# TECHNICAL SERVICE BULLETIN

Bulletin Number: **ATV-08-01A**  
**ATV-08-01B**  
Model Years: **2004.5 / 2005 / 2006**

### SUBJECT: SAFETY RECALL

**Replacement of Electronic Control Modules on Select Model Year 2004.5, 2005 and 2006 Sportsman 500s, Model Year 2005 Scrambler ATVs, Model Year 2005 Sportsman 400s, Model Year 2005 and 2006 Scrambler 500 4x4s, 2006 Sportsman 450s, 2005 Sportsman 600s, 2005 and 2006 Sportsman 6x6s, Carbureted 2005 and 2006 Sportsman 700s, and Carbureted 2005 Sportsman MV7.**

### Unpotted Die-Cast ECM

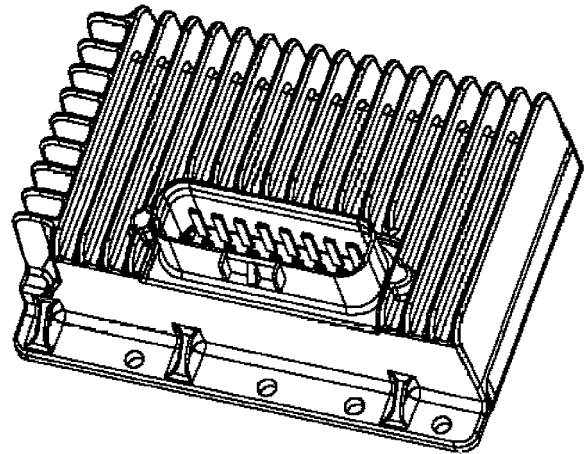
Polaris is revising and expanding prior Safety Bulletins ATV-05-01, ATV-05-01R, ATV-05-01T, ATV-05-01L, and ATV-05-01C under a newly issued Safety Bulletin, ATV-08-01. The revised and expanded bulletin/recall affects select Model Year 2004.5, 2005 and 2006 Sportsman 500s, 2005 Model Year Scrambler ATVs, Model Year 2005 Sportsman 400s, Model Year 2005 and 2006 Scrambler 500 4x4s, 2006 Sportsman 450s, 2005 Sportsman 600s, 2005 and 2006 Sportsman 6x6s, Carbureted 2005 and 2006 Sportsman 700s, and Carbureted 2005 Sportsman MVs. Polaris has determined some units in the revised and expanded VIN range were assembled with possibly defective Electronic Control Modules (ECMs) that may fail and overheat. If this were to occur, the excessive heat could cause fire, possibly resulting in serious injury or death. Units in the revised and expanded VIN range should have the previously used potted ECM replaced with a new unpotted Die-Cast ECM.

**NOTE: Affected units that have already had an unpotted Die-Cast ECM previously installed (see images on next page) are not affected by this current Safety Bulletin. No further action is required on these units.**

ECMs on units in the affected VIN range are to be removed and replaced with an unpotted Die-Cast ECM. Order 1 ECM kit for each affected ATV that is repaired. All affected units in dealer inventory are to be repaired prior to sale.

Affected models using ECM 4011044 will use ECM Replacement Kit PN 2203350.

Affected models using ECM 4011110 will use ECM Replacement Kit PN 2203348.
